Drawing Name : REWORK

DART SERVICE INSTRUCTION

TO AMEND INSTALLATION INSTRUCTIONS IIN-D350-636 REV E

FOR D350-636-011/-012/-013/-014 SKIDTUBES AT CHG 004:

FIGURE 1 - D350-636-011/-012/-013/-014 AT CHG 004 AND INSTALLATION OF DSI 9413-011
(LOCATION OF AN526C1032RXX SCREWS ARE NOT TO BE USED TO MOUNT WEARSHOES)

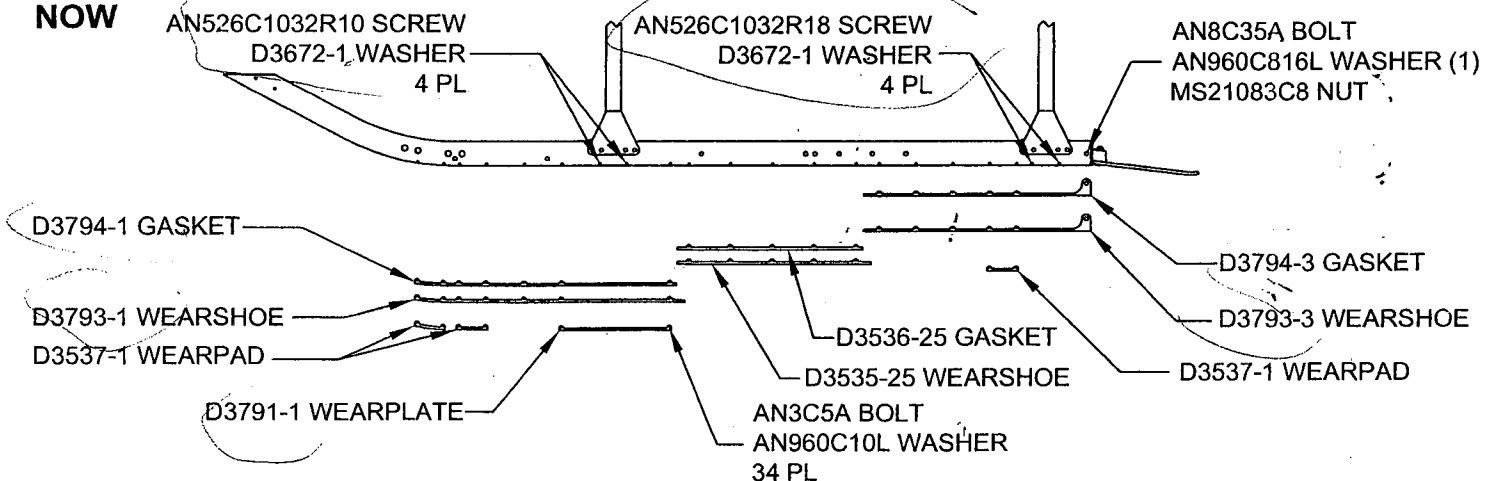
TO IMPROVE THE INSTALLATION OF THE DART D350-636-011/-012/-013/-014 SKIDTUBES ONTO THE CROSSTUBES, THE INSTALLATION AND PART NUMBERS OF THE FWD AND AFT WEARSHOES/GASKETS HAVE BEEN REVISED AS SHOWN IN FIGURE 1 BELOW.

WAS

NOW
